Product Change Notification / NTDO-28XWRK640

CCB 4758 Final Notice: Qualification of MPHL as an additional final test site for selected ATSAMA5D2xx device family in 289L LFBGA (14x14x1.4mm) package.

Pre and Post Change Summary

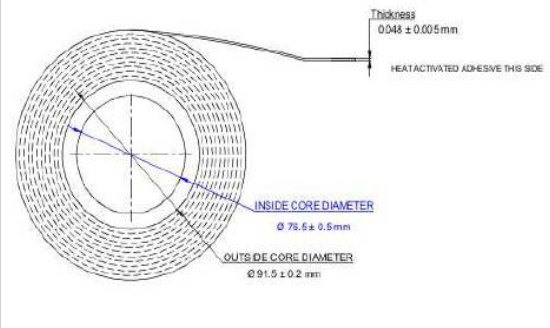
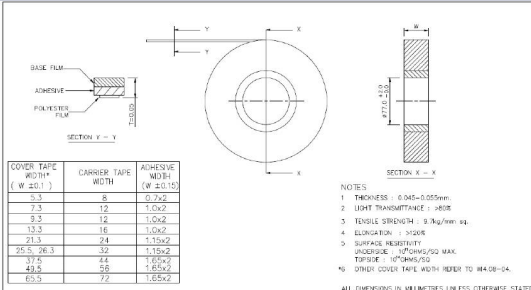
Final Test Location		ASE9	MPHL
Base Quantity Multiple (BQM)	T/R	1000	1000
	Tray	119	119
Packing Color	T/R	White	White
	Tray	Black	Black
Pin 1 Orientation		Quadrant 1	Quadrant 1

Pre and Post Change Summary

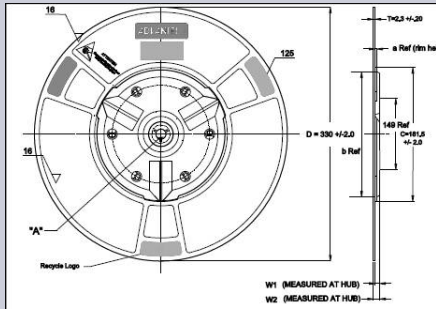
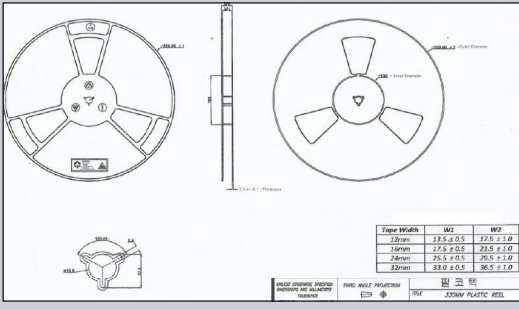
Final Test Location	ASE9	MPHL																								
Carrier Tape for T/R	 <table border="1" data-bbox="524 1213 945 1312"> <thead> <tr> <th>Width (mm)</th> <th>Pitch (mm)</th> <th>A0 (mm)</th> <th>B0 (mm)</th> <th>K0 (mm)</th> <th>Thickness (mm)</th> </tr> </thead> <tbody> <tr> <td>24</td> <td>16</td> <td>14.5</td> <td>14.5</td> <td>1.84</td> <td>0.3</td> </tr> </tbody> </table>	Width (mm)	Pitch (mm)	A0 (mm)	B0 (mm)	K0 (mm)	Thickness (mm)	24	16	14.5	14.5	1.84	0.3	 <table border="1" data-bbox="1101 1207 1521 1306"> <thead> <tr> <th>Width (mm)</th> <th>Pitch (mm)</th> <th>A0 (mm)</th> <th>B0 (mm)</th> <th>K0 (mm)</th> <th>Thickness (mm)</th> </tr> </thead> <tbody> <tr> <td>24</td> <td>16</td> <td>14.5</td> <td>14.5</td> <td>1.84</td> <td>0.3</td> </tr> </tbody> </table>	Width (mm)	Pitch (mm)	A0 (mm)	B0 (mm)	K0 (mm)	Thickness (mm)	24	16	14.5	14.5	1.84	0.3
	Width (mm)	Pitch (mm)	A0 (mm)	B0 (mm)	K0 (mm)	Thickness (mm)
